MANDATORY SERVICE BULLETIN

MSB 40-067

Check of emergency exit lever.

Check of emergency exit lever

Quantity	Part No.	Description
1 if required	DA4-5200-71-00_1	Emergency exit lever

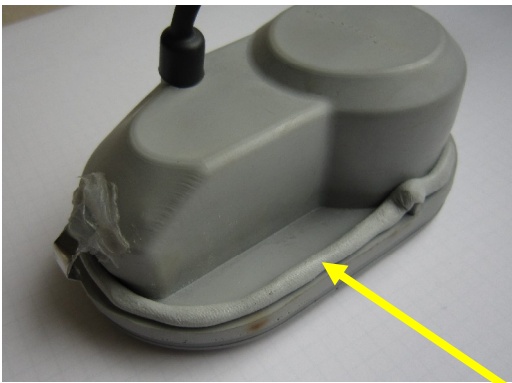
5	<p>Rework lever pin, refer to picture.</p> <div style="display: flex; justify-content: space-around; align-items: center;"> <div style="border: 1px solid black; padding: 5px; width: 150px;"> <p>Bend the pin if necessary maximum 3°</p> </div>  <div style="border: 1px solid black; padding: 5px; width: 150px;"> <p>Grind surface maximum 0,3mm (0,012 inch) and edge 3mm (0,12 inch) if necessary</p> </div> </div> <p style="text-align: center;">The minimum pin diameter is 5,7mm (0.225 in).</p>
6	<p>Install the modified emergency lever and test the release with hand force. If a release is possible, install the emergency exit lever.</p>
7	<p>If a release is not possible, replace the emergency exit lever with DA4-5200-71-00_1.</p>
8	<p>Seal reading light and emergency lever with Terostat IX.</p> <div style="display: flex; justify-content: space-around; align-items: center;">   </div> <div style="text-align: center; margin-top: 10px;"> <div style="border: 1px solid black; padding: 5px; display: inline-block;"> <p>Sealing Terostat IX</p> </div> </div> <p>CAUTION: Do not use silicone or any equivalent to seal the gap.</p>
